National Transportation Safety Board

Safety Recommendation

Date: July 17, 2009

In reply refer to: A-09-55 through -60

Figure. Diagram of a Learjet 60's lights on the main annunciator panel.

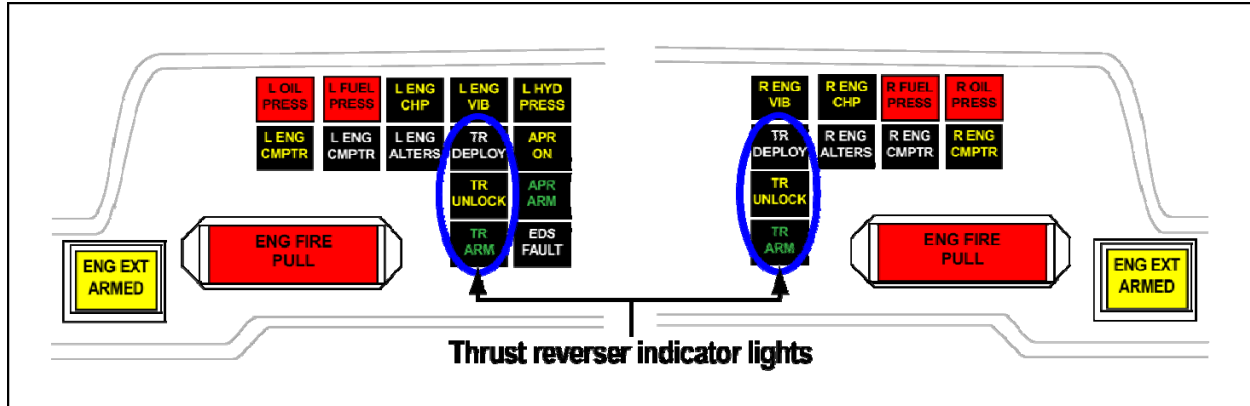
Normally, six lights⁷—three for each engine—will illuminate on the forward instrument panel to indicate the status of the thrust reversers (see figure). Each bottom light (TR ARM) is green and indicates that prerequisites for reverse thrust exist, such as the availability of hydraulic pressure to deploy the engine thrust reversers. Two of the conditions that trigger the TR ARM lights and that would be apparent to the pilots were that (1) the squat switches sense that the aircraft is in ground mode, and (2) the engine power levers are in the idle positions. The TR ARM lights denote that the reverse levers can be moved upward if the pilot elects. Because these lights are normally on when the engines are at the idle position on the ground and go out whenever the engine power levers are moved to and from idle, the pilot can become conditioned to these lights going on and off during normal taxi.

When the reverse levers are raised to the DEPLOY position, hydraulic pressure unlocks the engine thrust reverser doors, and, subsequently, two amber lights (TR UNLOCK) will illuminate to indicate that both thrust reverser doors are unlocked. When the amber TR UNLOCK lights illuminate, the green TR ARM lights extinguish. After the engine thrust reverser doors are fully deployed, two white lights (TR DEPLOY) illuminate, and the amber TR UNLOCK lights extinguish.

If, during a rejected takeoff, there were an inadvertent thrust reverser stowage due to loss of the requirements for maintaining reverse thrust, the following indications would occur:

- The white TR DEPLOY light(s) would extinguish,
- The amber TR UNLOCK light(s) would illuminate momentarily, and
- The green TR ARM light(s) would blink momentarily.⁸

The only indication available to the pilots that the cockpit reverse levers and engine thrust reversers were not in agreement would be the pilots' comprehension that neither of the TR DEPLOY lights was illuminated while the reverse levers were in the positions normally associated with reverse thrust. The NTSB concludes that, during a rejected takeoff, which requires quick and concentrated pilot actions, it may be difficult for a pilot to recognize the significance of the absence of reverse thrust indicator lights.

Require Learjet to develop and install improved aural or visual cues on future-manufactured Learjet 60 airplanes that would allow pilots to recognize an inadvertent thrust reverser stowage in a timely manner. (A-09-57)

Once improved aural or visual cues are developed per Safety Recommendation A-09-57, require Learjet 60 operators to install those cues on existing Learjet 60 airplanes. (A-09-58)
